**CHARTER TOWNSHIP OF VAN BUREN  
PLANNING COMMISSION AGENDA  
Wednesday, August 10<sup>th</sup>, 2022 – 5:30 PM  
Van Buren Township Hall  
46425 Tyler Road**

**Subject: VBT-22-012 Chahal Transport - Schooner Drive; Special Land Use Review #1  
Revised Site Plans Dated February 16, 2022 (Received May 17, 2022)**

**Subject: VBT-22-012 Chahal Transport - Schooner Drive; Site Plan Review #3  
Revised Plans Dated June 21, 2022 (Received July 5, 2022)**

## **Chahal Semi Truck/Trailer Repair Facility Site Plan Preliminary Site Plan Review #2**

SITE PLAN

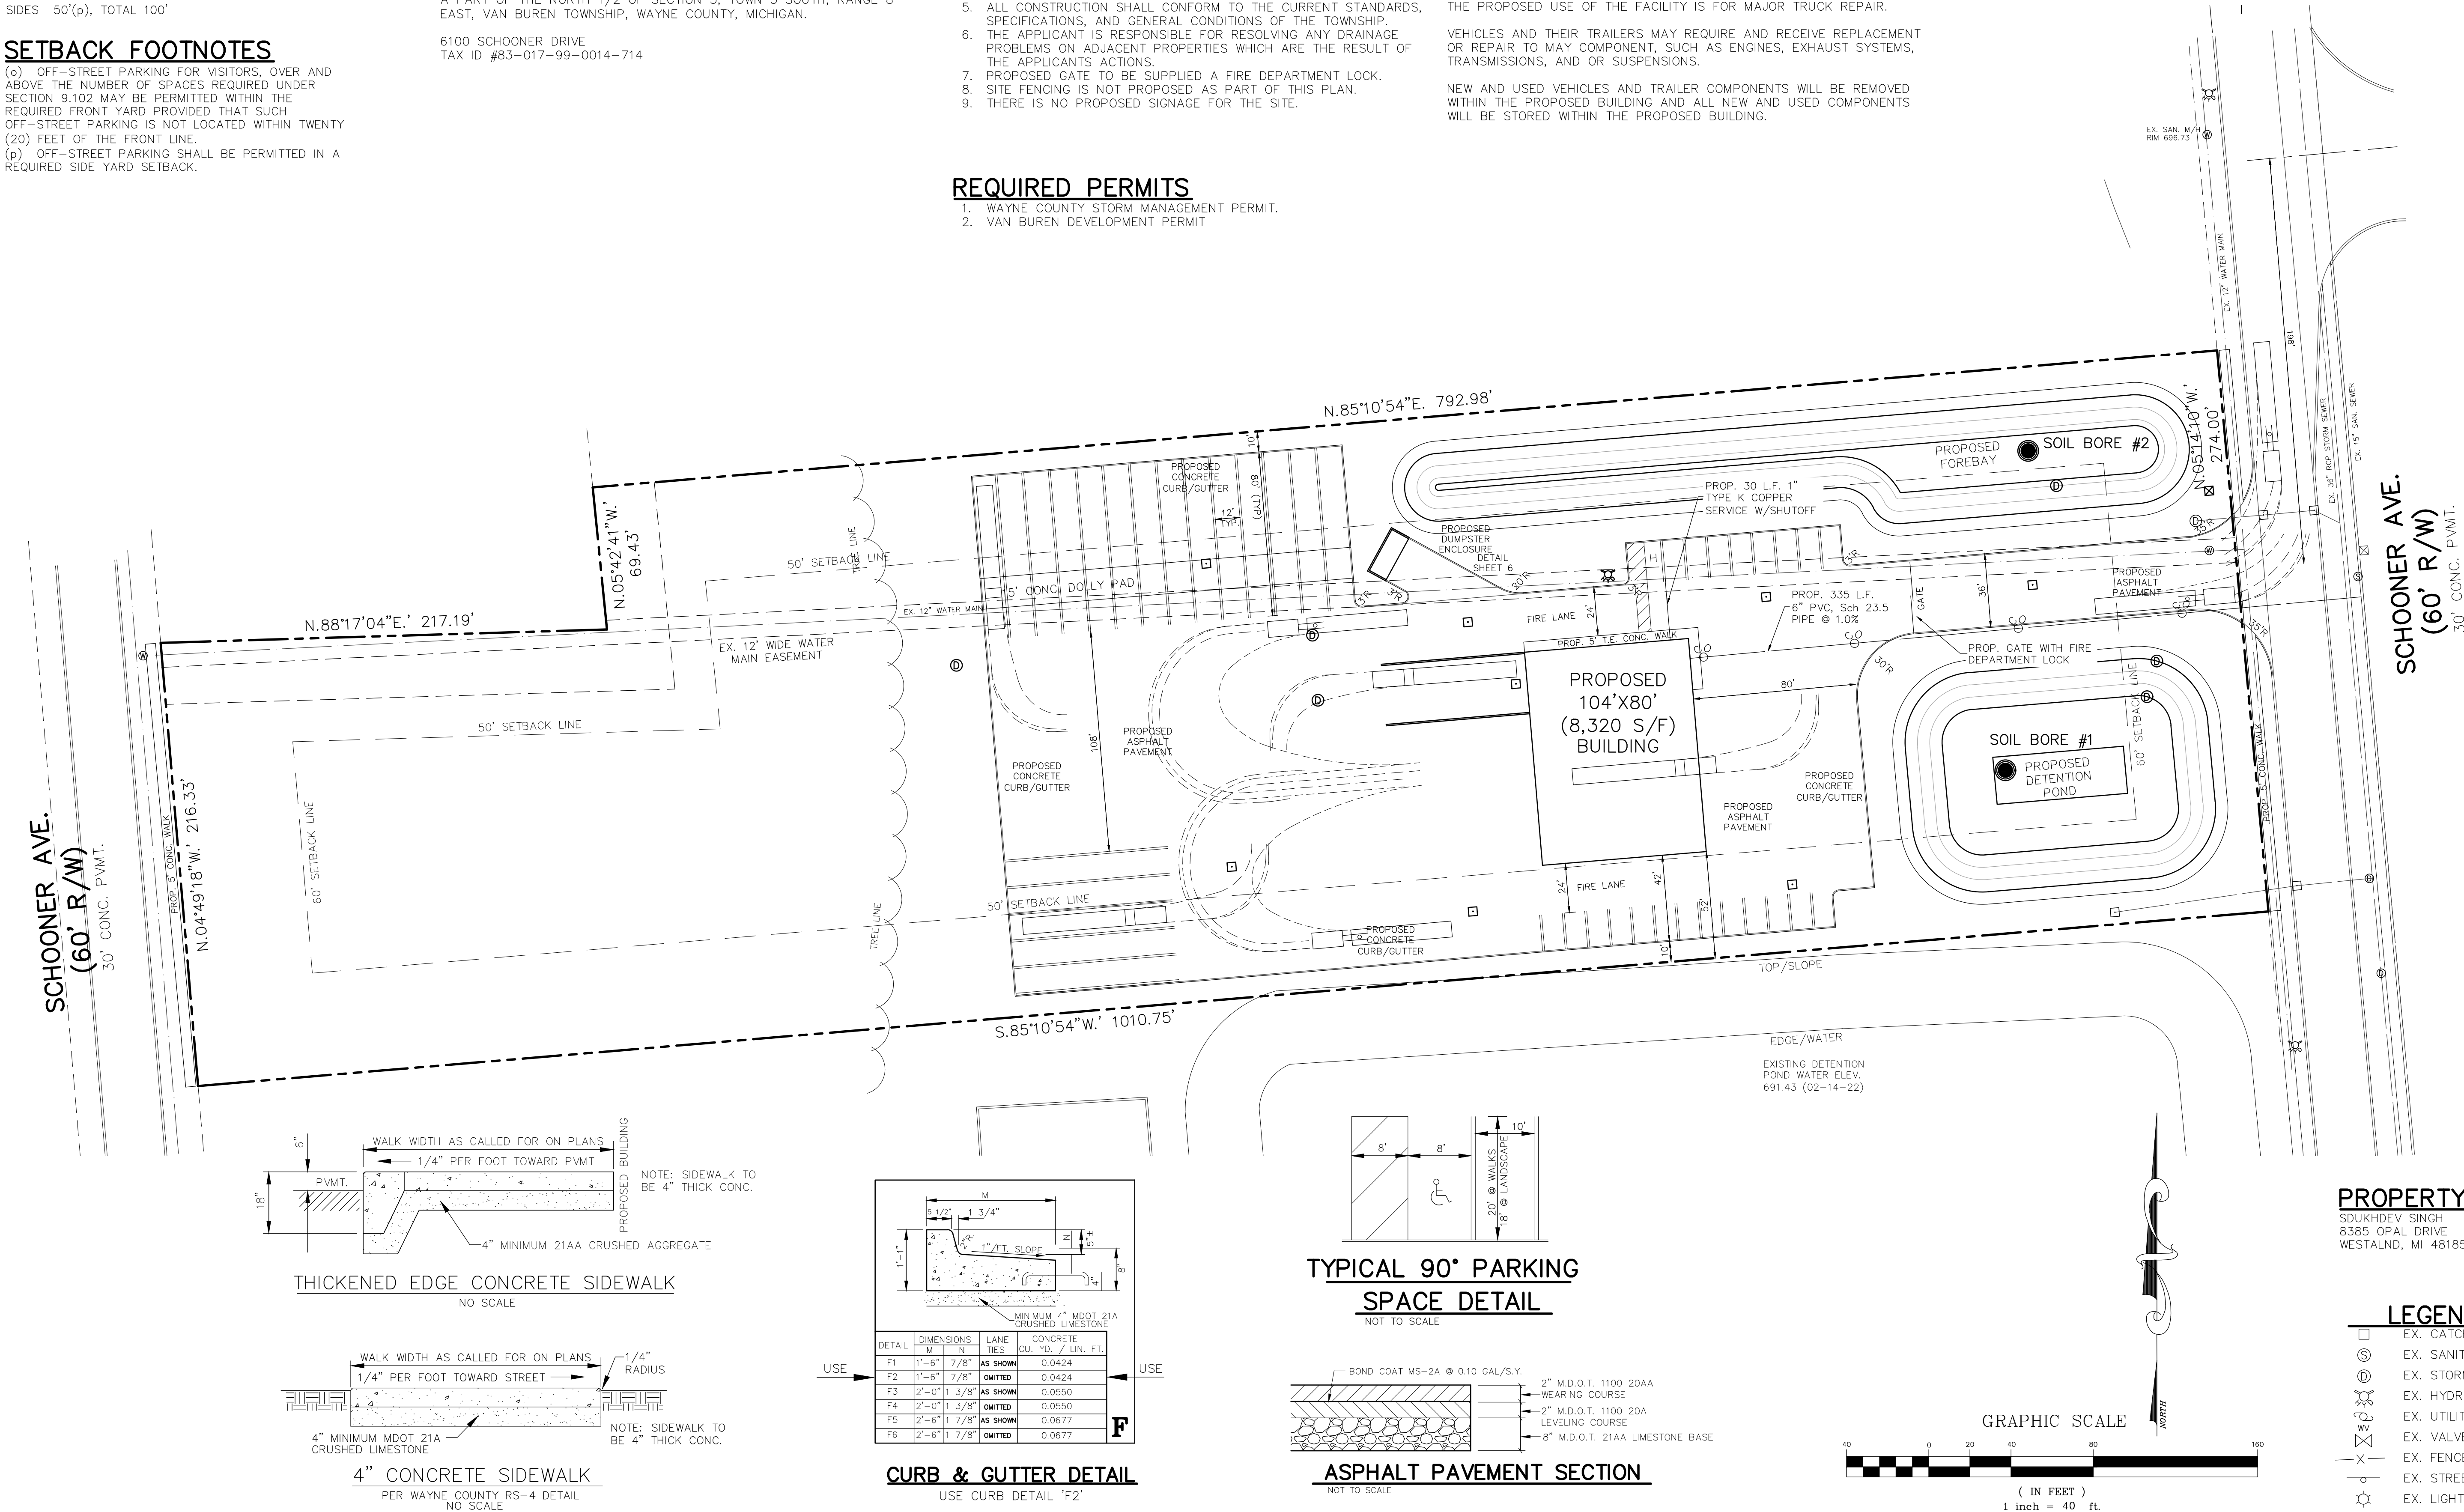
4. **Access and Circulation.**
  - a. **Location of Curb Cuts and circulation.** The site plan includes a new curb cut off Schooner Drive (east) which appears to be intended for 2-way movement of vehicles. The width of the access drive is noted at 36 feet. The applicant has provided a truck circulation diagram which shows truck movement throughout the site.

Per the revised site plans, fire lane access has been provided around the building. The access drive on the south side is shown as 24' wide which implies two-way movement of vehicles; originally, the parking abutting it was angled for one way parking. The revised plans show the spaces oriented at 90 degrees. Sufficient turnaround space for the truck trailer spaces has been provided.

- b. **Cross Access.** No cross-access drives are proposed for the site.
  - c. **Sidewalks.** A new 5-foot sidewalk is proposed along the site's Schooner Drive frontage (east and west). An interior sidewalk 5 feet in width has been proposed on the north and partially along the east side of the building to provide pedestrian access from the parking lot to the building entrances on the north and east sides of the building via a crosswalk..

The plan also includes 19 truck parking spaces along the northwest and southwest property lines dimensioned at 12' x 80' with turning area for maneuvering. Trucks parked in these spaces are noted to be awaiting repair, with no junk parts being stored or salvaged.

- c. **Barrier Free Spaces.** The plan indicates one (1) barrier free space, as required for parking lots containing 1-25 parking spaces. A striped crosswalk has been provided from the space leading to the proposed sidewalk. An ADA accessible ramp must be clearly shown on this portion of the sidewalk.
- d. **Loading.** For the proposed building size, one (1) 10 ft. x 25 ft. loading space is required. A 24 ft. x 80 ft. truck well is proposed at the northwest corner of the building to accommodate two loading areas and is compliant with the Ordinance.

11. **Dumpster.** The site plan notes a dumpster enclosure on the northern portion of the site, between the passenger parking and semi staging areas. The enclosure is to be constructed of block, with face brick and provided with a cap. The gates are to be constructed of steel panels. The brick color must match the building façade color.
12. **Signs.** It is noted on the plans that no signs are being proposed for the site. If signs are proposed at a future date, they must be submitted for administrative approval.
13. **Other.** The plan notes a gate at the main entrance drive into the site. Details of the proposed gate have been noted in addition to a note providing for fire department access. No fences are proposed as part of this plan.

**Per the site plan (2<sup>nd</sup> page) under site “specific notes” #7 to avoid confusion, the Fire Department requires a Knox Padlock for the manual gate. The Fire Department does not supply the lock**

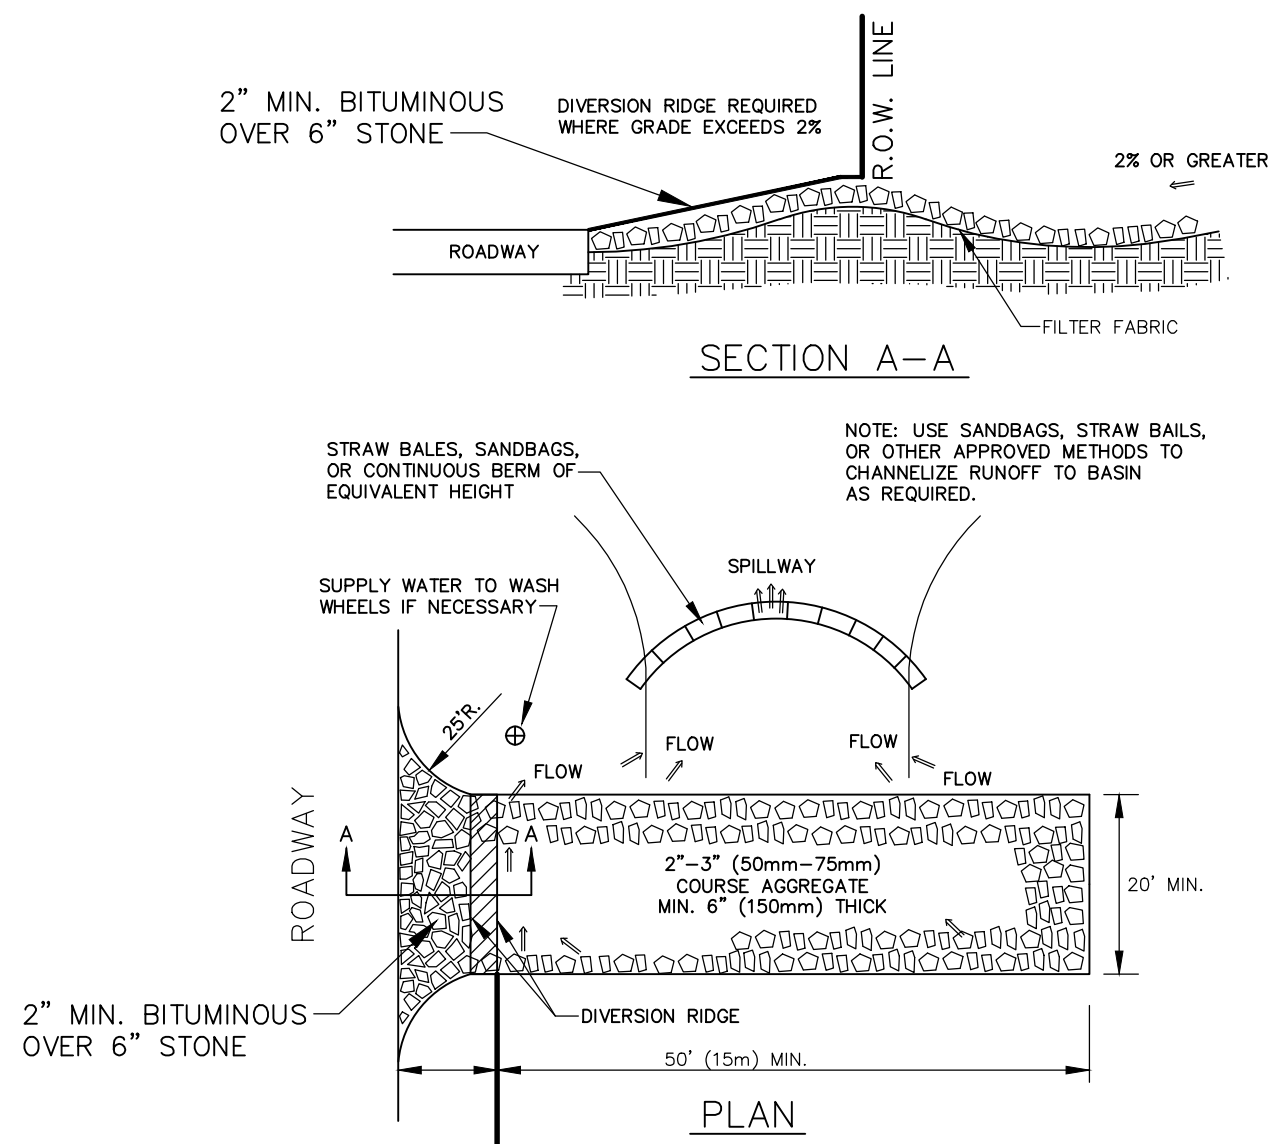
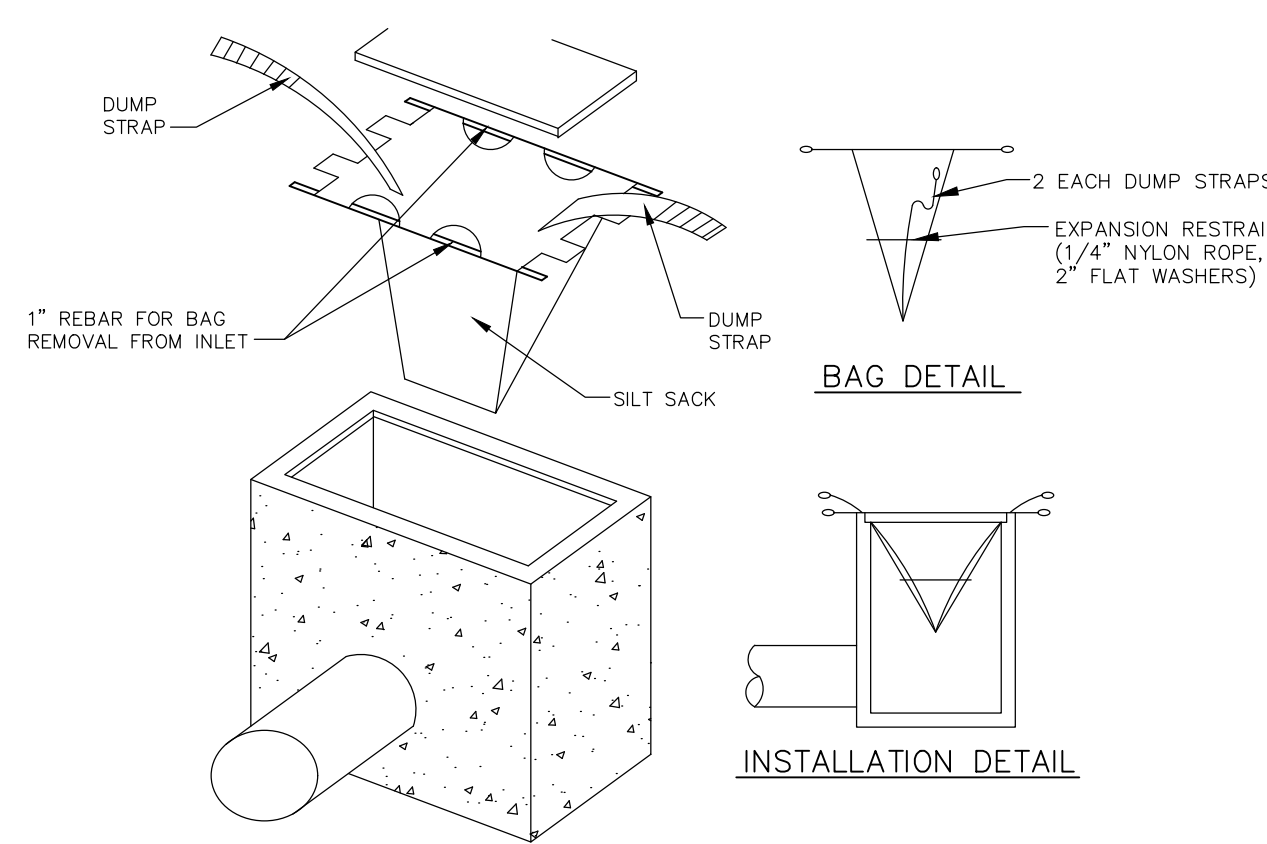
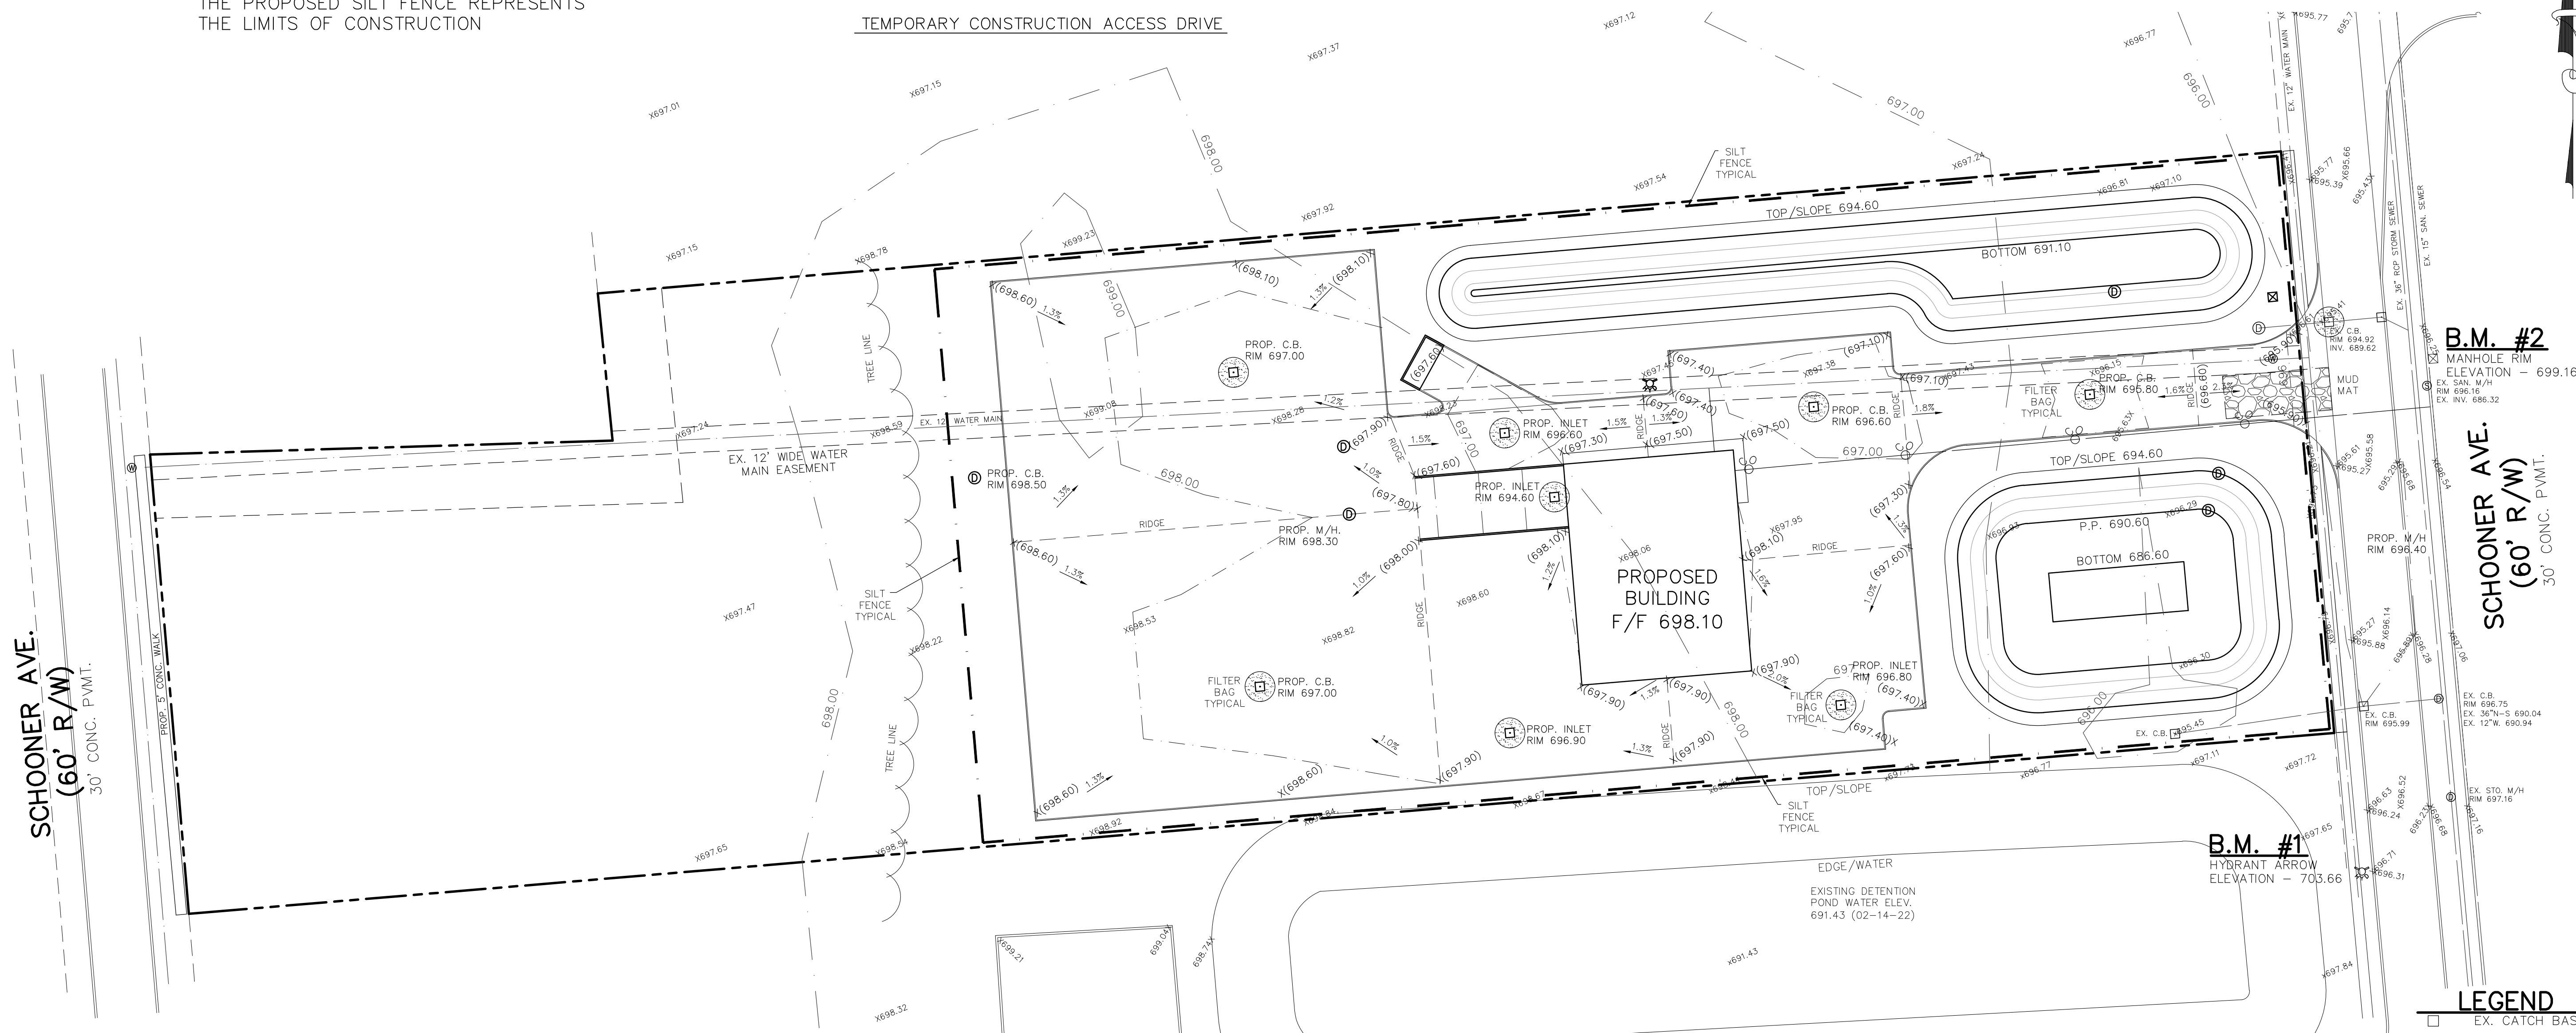
1. Make sure the SESC plan provided is clear and concise, showing all elements that are needed for all areas of earth disturbance, and in accordance with the Township *Engineering Standards Manual*, Chapter II, Plan Requirements, Paragraph D, SESC Plan Requirements, and in accordance with Wayne County SESC standards. A permit must be acquired from the Wayne County SESC County Enforcing Agency.  
<https://www.waynecounty.com/departments/environmental/landresources/soil-erosion.aspx>.

2. SESC plans should show all elements in a key/legend and easily be discernible on the plans. The silt fence line type does not match between legend and plans.

3. Sediment/inlet filters need to be added to existing catch basins in the roadway at the entrance and in the southeast area of the site, both in the road and on the property. Any structure that accepts flow into the existing system that could carry sediment needs to be protected.
